**Before a Hearings Panel Appointed by the  
Selwyn District Council and Canterbury Regional Council**

applications under section 88 of the  
Act by Bathurst Coal Limited in  
relation to the closure and  
rehabilitation of the Canterbury Coal  
Mine in the Malvern Hills, Canterbury

**Statement of Evidence of  
Sioban Doreen Hartwell (Water Quality)  
for Bathurst Coal Limited**

Dated: 1 October 2021

Figure 2 – Compliance Monitoring Locations

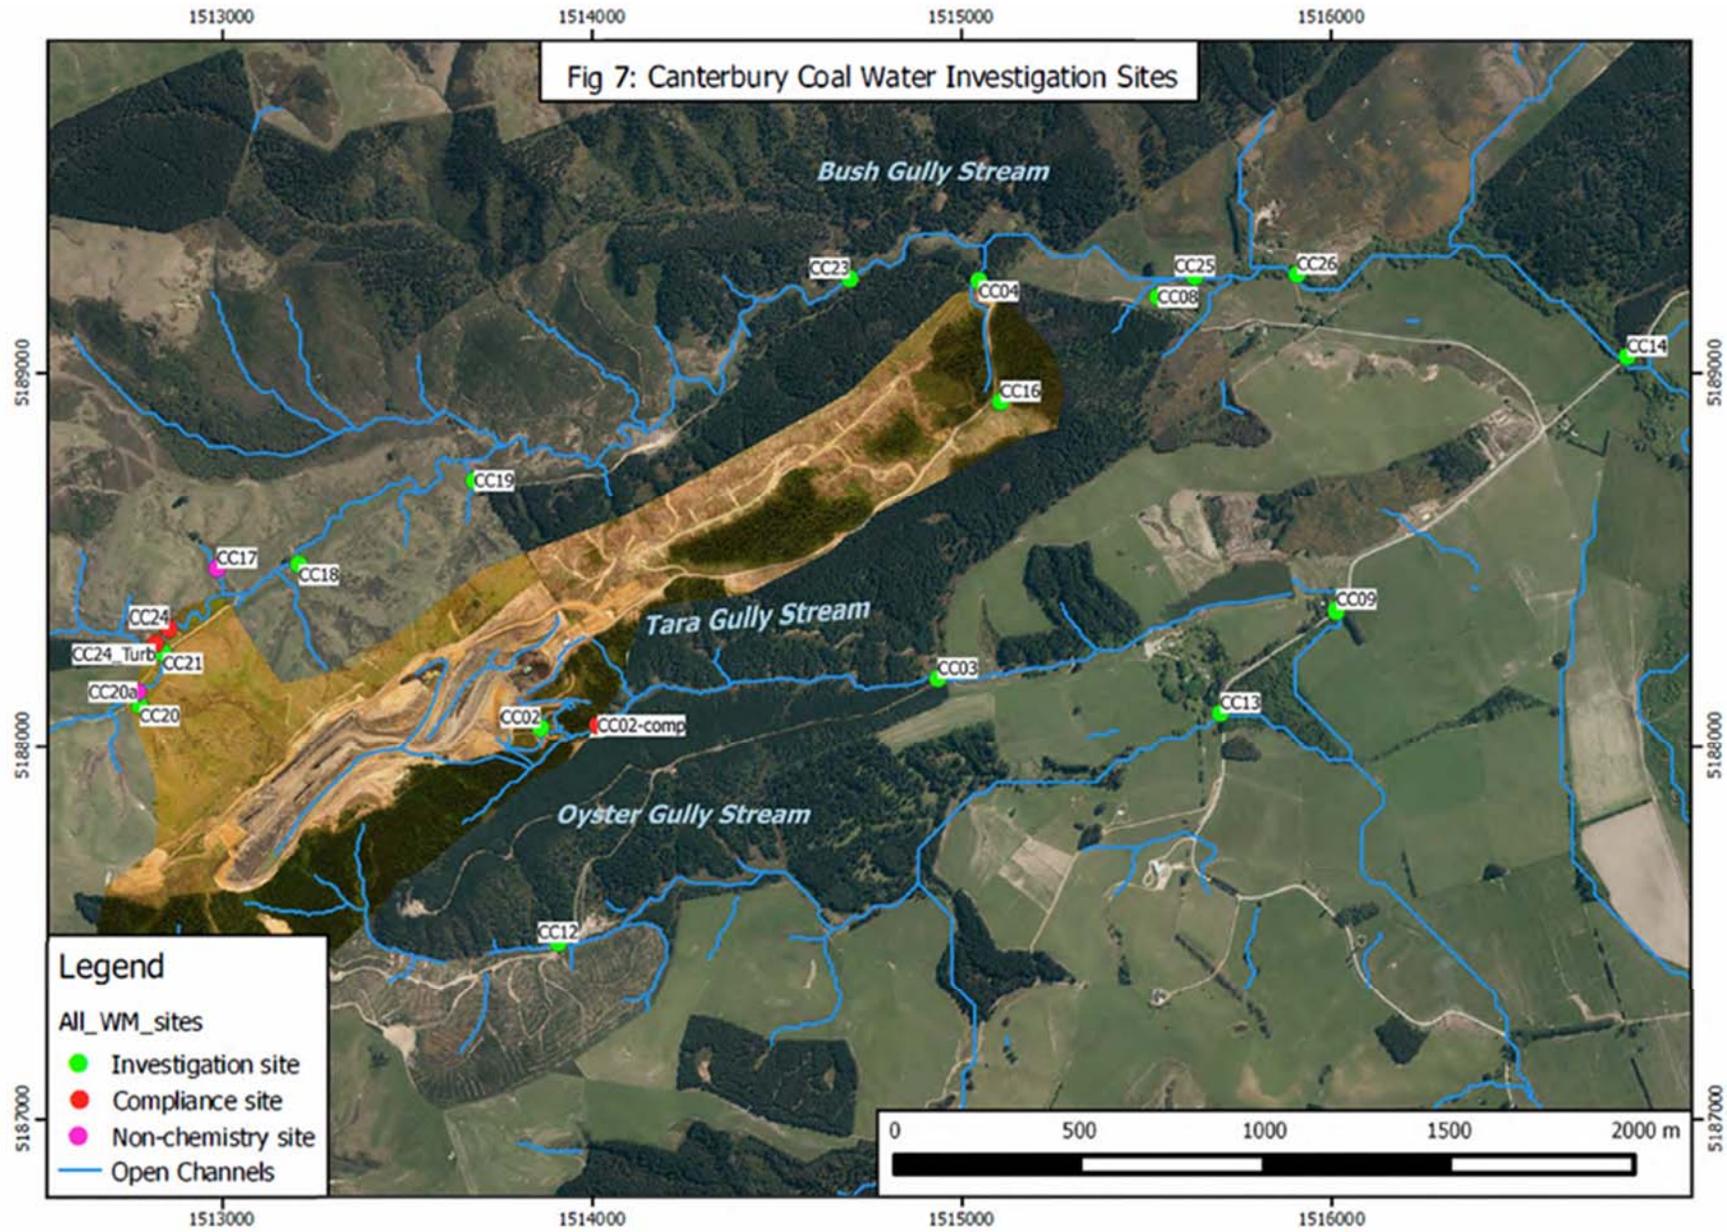
21. Discharged water quality is monitored at numerous locations within the mine site and downstream. These sites are shown in **Figure 2** attached to my evidence at **Appendix 3**.

22. BCL have existing conditions relating to turbidity that they are required to meet at monitoring sites CC02 and CC24 . The unit used for measuring turbidity is NTU which stands for Nephelometric Turbidity Unit. The higher the concentration of suspended solids in the water the higher the turbidity measurement. The values BCL are required to meet are:

- (a) No more than 50 NTU at CC02 (CRC170541)
  - (b) Less than 50 NTU increase from CC24\_turb, at CC24 (CRC173823)
23. Total Suspended Solids (**TSS**) values are measured monthly. There is no consent requirement for TSS except for a correlation between TSS and turbidity to be derived and reported annually. This correlation is useful because the turbidity measurements are continuous (every 15 minutes) and the correlation can then be used as an indication of TSS levels.

Figure 3 - Proposed Final Drains

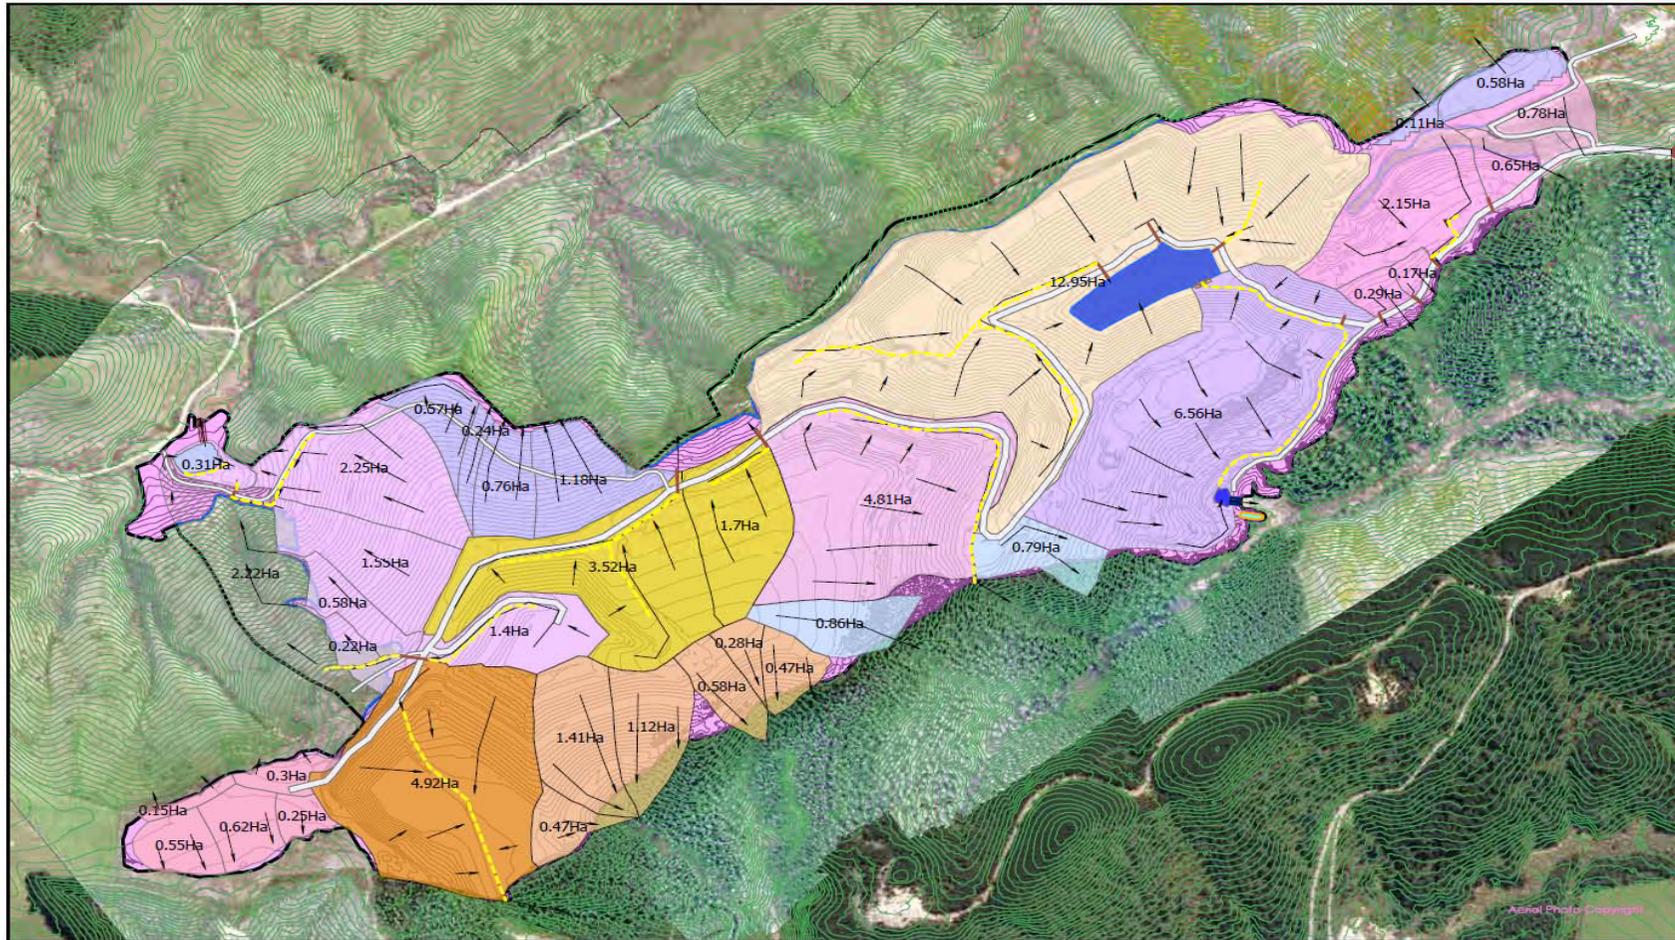
29. My understanding is that the CCM site will be returned post closure to either pasture or forestry. The closure plan developed by BCL involves re-contouring the CCM site to suit these land uses. I have attached the proposed closure drainage plan for reference as **Figure 3 at Appendix 3**.
30. The recontouring has included review of drainage patterns and re-shaping where practical to avoid flow concentration. Where drains are required to

collect and convey surface water off site, BCL has adopted a 100 year return period design criteria. In my opinion this is an appropriate design criteria for permanent drains since it means there is a low probability of the drains being over-topped and the scour protection is in turn designed for a relatively rare event. This level of protection aligns with the design criteria applied for permanent diversion drains at other mine sites in New Zealand I have been involved with (e.g. Cypress mine Stockton)

31. I have reviewed the Surface Water Management Report and associated calculations spreadsheet, with my team at GHD. The aim of the review was to confirm, (and if necessary, refine), the approach used by BCL and check accuracy. To this end, spot checks on drain sizes were undertaken on values in the report by:

32. Based on this review I consider the methods used by BCL for drainage sizing to be in line with accepted engineering standards and to have been applied correctly. Furthermore, BCL's selection in both assumptions (rainfall data) and in design outputs (riprap size, culvert size etc.) are generally conservative (i.e., over designed).

33. Given the conservative approach taken to drainage design I would expect these drains to perform well. I do note that the drain sizing's are based on final

landforms and associated catchment definitions, hence there is a risk that after handover these catchments are inadvertently changed. It is thus important that as part of handover to farming/forestry this risk is acknowledged and the landform and catchment retained through ongoing compliance with the conditions of consent.
